REVISED RESPONSE TO REQUEST FOR ADDITIONAL INFORMATION

APR1400 Design Certification

Docket No. 52-046

RAI No.: 269-8319
SRP Section: 09.02.02 – Reactor Auxiliary Cooling Water System
Application Section: 09.02.07
Date of RAI Issue: 10/22/2015

Figure 9.2.7-1 Essential Chilled Water System Flow Diagram (Sheet 4 of 4)

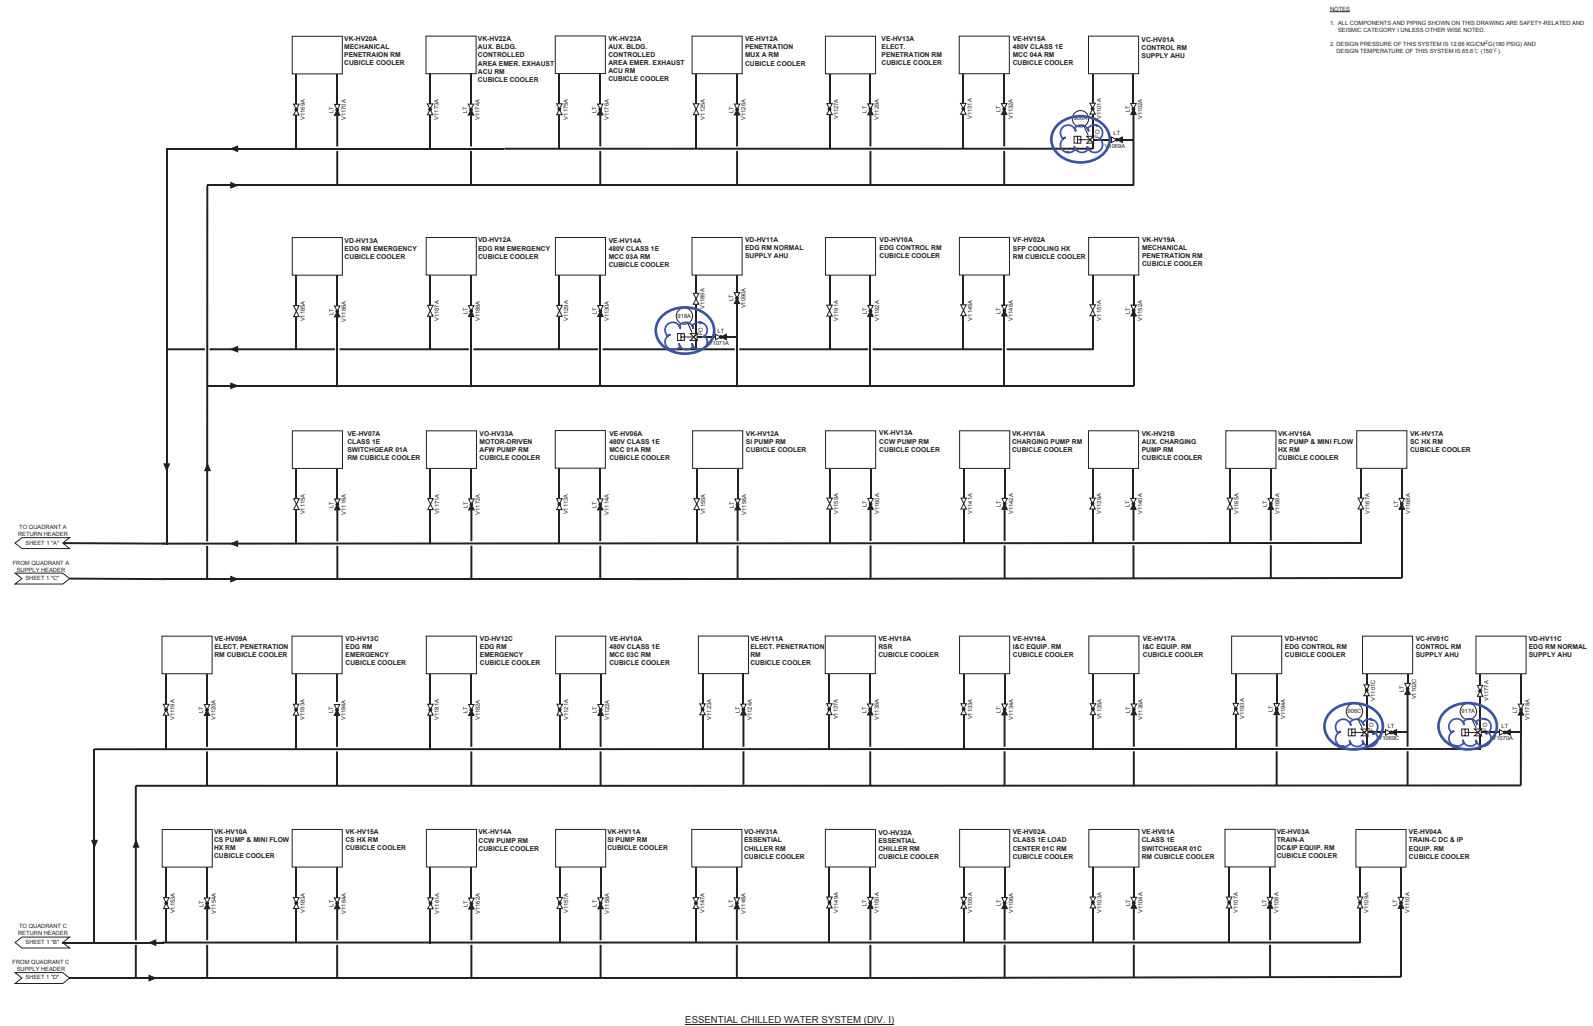
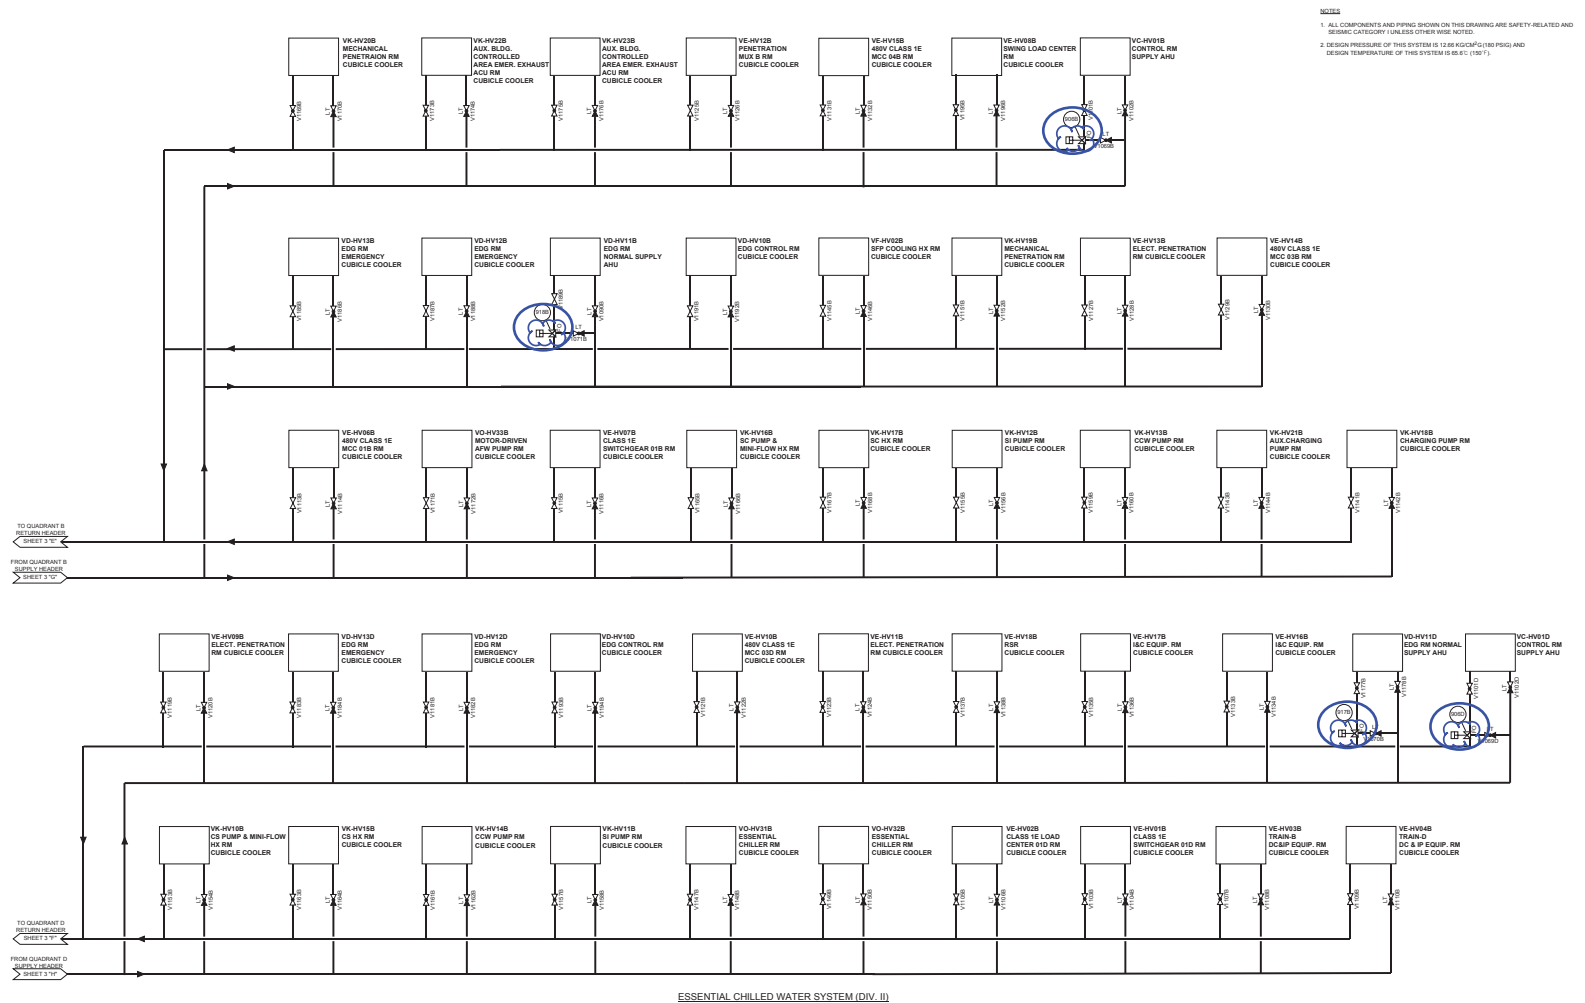
- a) Nominal pipe sizes are not shown on the DCD Tier 2, Section 9.2.7, figures and the system description does not explain the criteria that are used for establishing the appropriate pipe sizes (e.g. limiting flow velocities).

- b) Filters or strainers are not shown in the DCD Tier 2, Section 9.2.7 figures and DCD Tier 2, Section 9.2.7, does not discuss how particulate and other foreign material will be controlled in the system.

- c) SRP 9.2.2 specifies that essential components and subsystems can function as required in a loss of offsite power and instrument air systems. DCD Tier 2 describes the ECW control valves as air-operated three-way control valves that fail open upon a loss of control signal or electrical power. However, the DCD does not discuss or evaluate the impact the ECW control valves have on the system when they fail closed due to loss of instrument air.

- a) Figure 9.2.7-1 is a simplified flow diagram; therefore, nominal pipe sizes are not shown. The pipe in the essential chilled water system is sized in accordance with engineering practices that determine appropriate pipe size to limit chilled water velocity in the pipe to below the design guideline velocity.

- b) Strainers are installed in the construction phase and removed prior to plant operation. The essential chilled water system is a closed-loop system, and impurities cannot infiltrate into the system. The essential chilled water system is filled and circulated with clean demineralized water; therefore, a filter or strainer is not required or provided in the system during plant operation and is not shown in Figure 9.2.7-1.

- c) The ECW control valves are air-operated three-way valves that are designed to be fail open upon loss of instrument air. DCD Tier 2, Subsection 9.2.7.2.1 will be revised to indicate that the ECW control valves are fail open upon loss of instrument air and DCD Tier 2, Figure 9.2.7-1 will be revised to change the symbol of the ECW control valves to be consistent with the symbol used as fail open for control valves in DCD Tier 2, Figure 1.7-1.

DCD Tier 2, Subsections 9.2.7.1.2, 9.2.7.2.1, and [Figure 9.2.7-1](#) will be revised as shown in the Attachment.

Figure 9.2.7-1 Essential Chilled Water System Flow Diagram (Sheet 1 of 4)

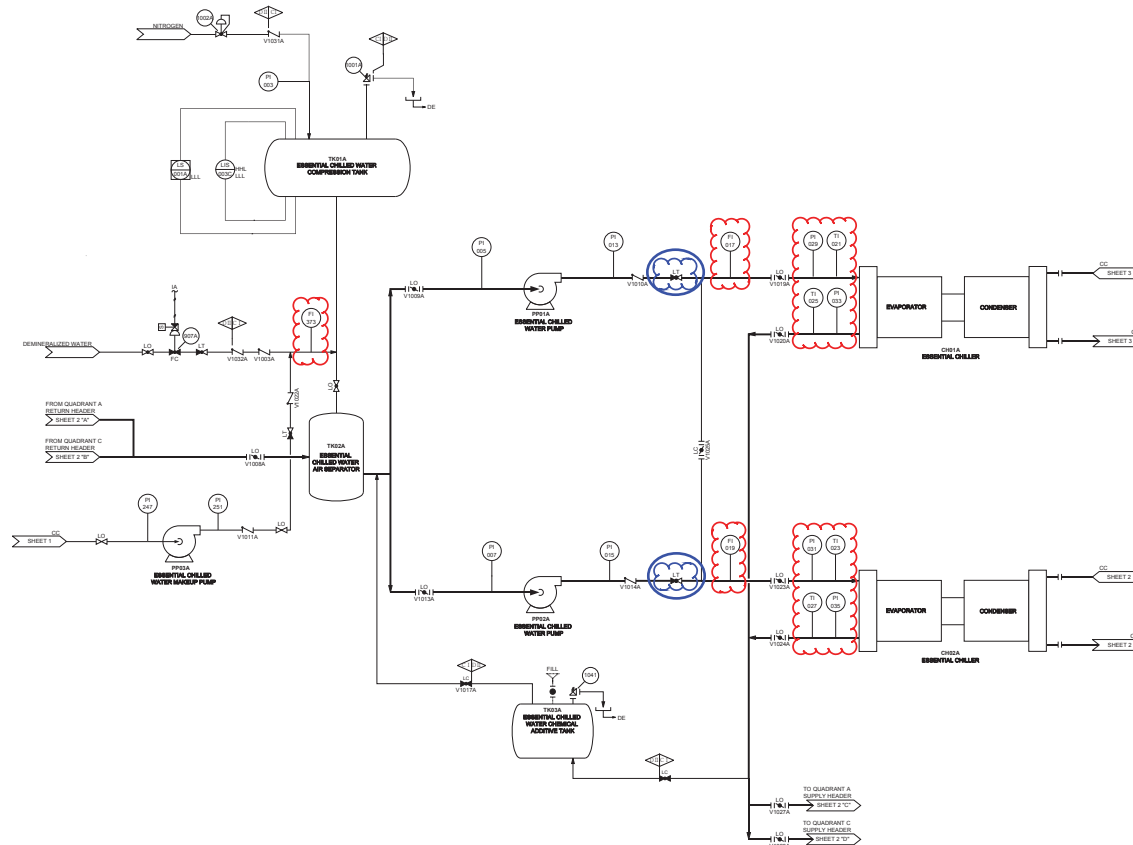
- a) All portions of the ECWS are accessible in the auxiliary building
- b) The current design allows for component maintenance due to the absence of isolation/maintenance valves.

- b) Isolation valves are provided on the inlet and outlet of components such as essential chillers and essential chilled water pumps to provide component isolation during component maintenance. Butterfly valves are provided on the inlet and outlet of the essential chillers as shown in Figure 9.2.7-1. And a butterfly valve is provided on the suction side of each essential chilled water pump and a globe valve is provided on the discharge side of each essential chilled water pump. However, the globe valves are not currently shown in Figure 9.2.7-1. Figure 9.2.7-1 will be revised to add a globe valve on the discharge side of each essential chilled water pump. The existence of isolation valves will not be described additionally in the DCD.
-

DCD Tier 2, subsection 9.2.7.1.1.1 [and Figure 9.2.7-1](#) will be revised as shown in the Attachment.
